(Shoreham Nuclear Power Station,
Unit 1))

PREPARED DIRECT TESTIMONY OF

SUFFOLK COUNTY CONTENTION 16

ANTICIPATED TRANSIENTS WITHOUT SCRAM (ATWS)

COMPARISON OF ATWS CONTRIBUTION TO FREQUENCY TO CORE MELT ACCIDENTS IN TWO BWR-4 REACTORS; ONE WITH AUTOMATED SLC (LIMERICK) AND ONE WITH MANUAL SLC (SHOREHAM). */

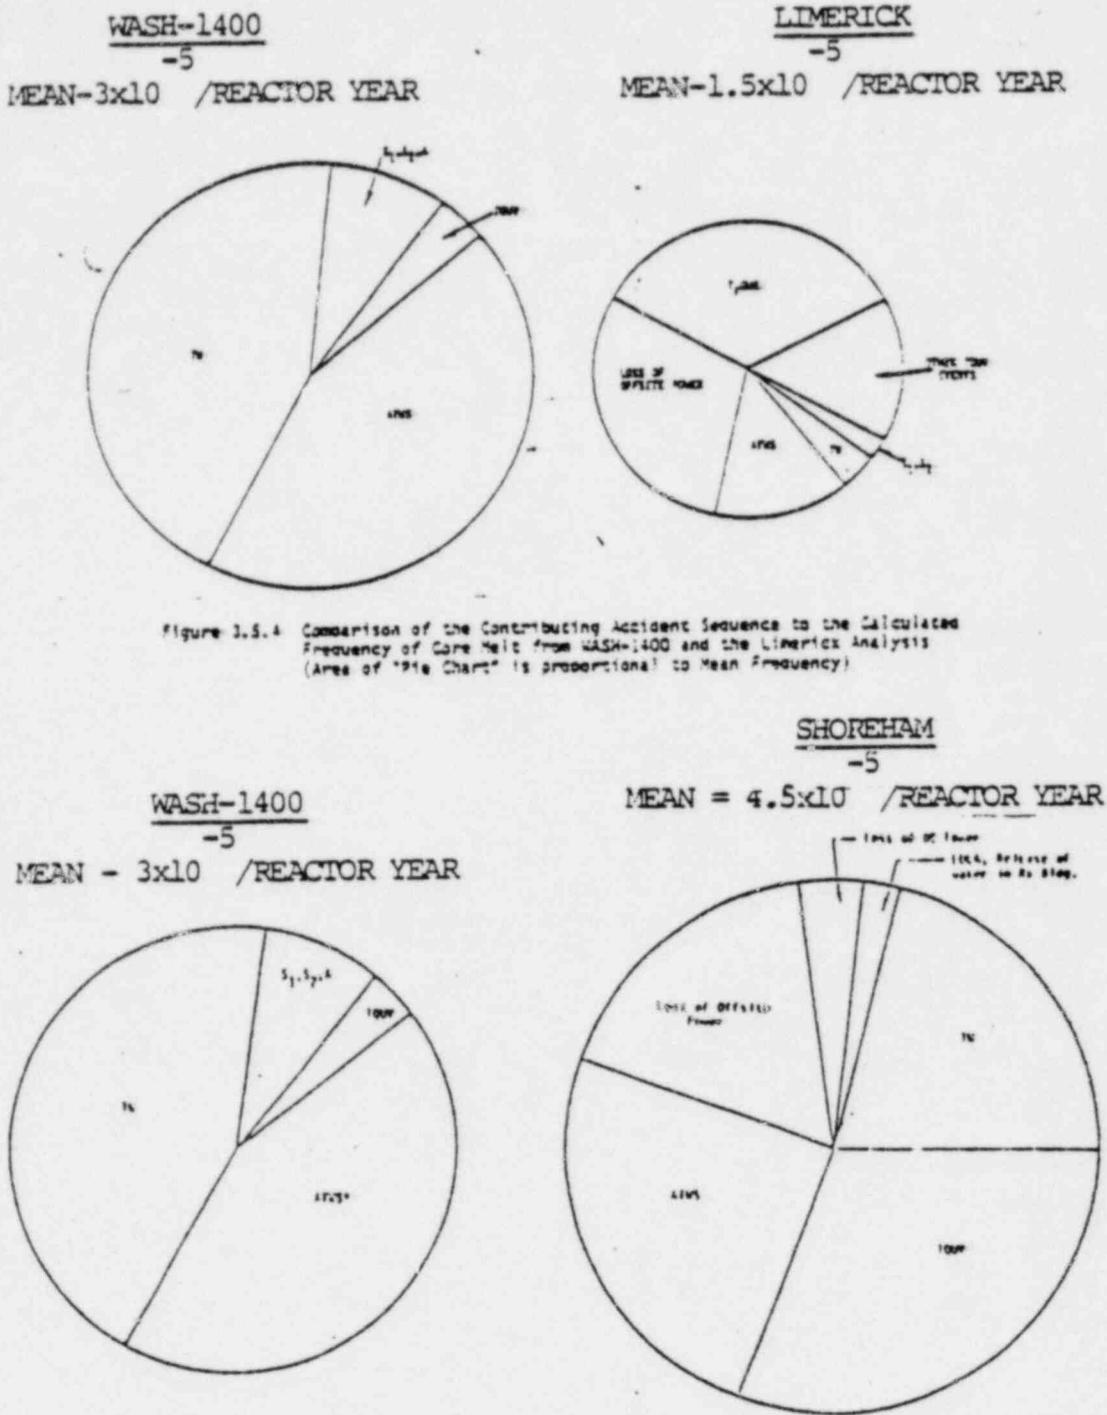
15. Another available comparison is to look at a "pie chart" distribution of core vulnerability events resulting from different contributing sequences. Since both PRAs have a similar chart, these are reproduced in Figure 1 for comparison. They also show the Wash-1400 values as a third comparison. Ignoring for now the exact values, the relative data are meaningful to show how the addition of ATWS mitigating techniques (including SLCS automation, larger SLC flow rate, and containment overpressure relief (COR)) have substantially reduced at Limerick the ATWS contribution to the calculated frequency of core vulnerability and core melt accidents. In addition, ATWS for Limerick is a smaller piece of a smaller pie. Improvements in the Shoreham SLC, including automation, would reduce both the ATWS contribution and the overall calculated frequency of core vulnerability and core melt.

* Subsequent to WASH-1400, NRC evaluations of the potential contribution of ATWS to core melt (e.g., NUREG-0460) placed the frequency of ATWS at a BWR at nearly twenty times that evaluated in WASH-1400. If this were incorporated into the figure it would be the single dominant contributor to core melt, and would be significantly larger than the frequency of core melt calculated for Shoreham.

Figure E.1. Simplified BWR event tree.

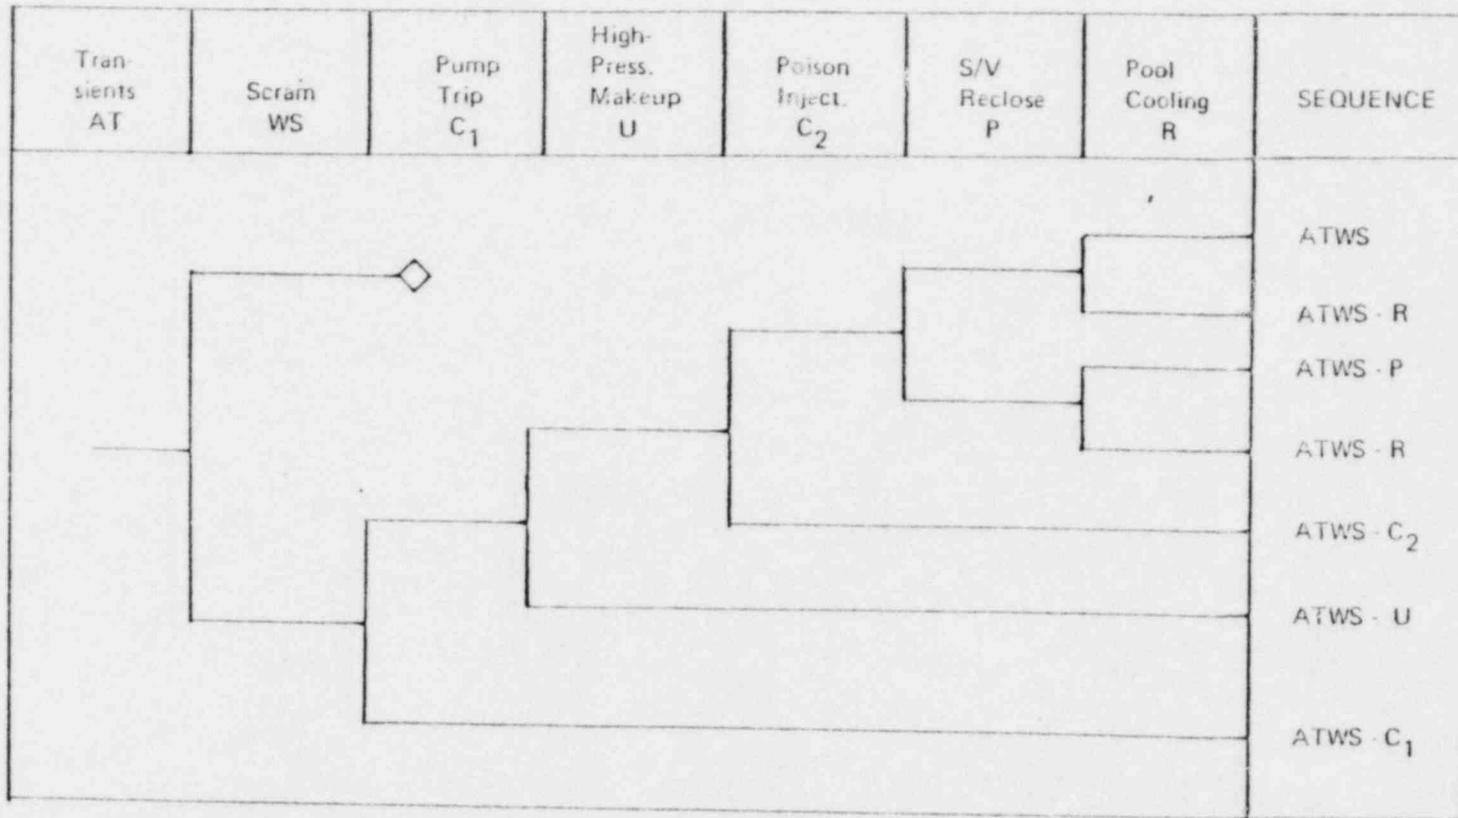
a non-automated, 43 gpm system (Alternative 2A)^{13/} more often lead to core vulnerability or core melt than for an automated 86 gpm system^{14/} (Alternative 3A). Additionally, NUREG-0460 shows that an automated, higher flow rate (2-400 gpm) system (Alternative 4A) is capable of mitigating even a wider range of ATWS consequence.^{15/}
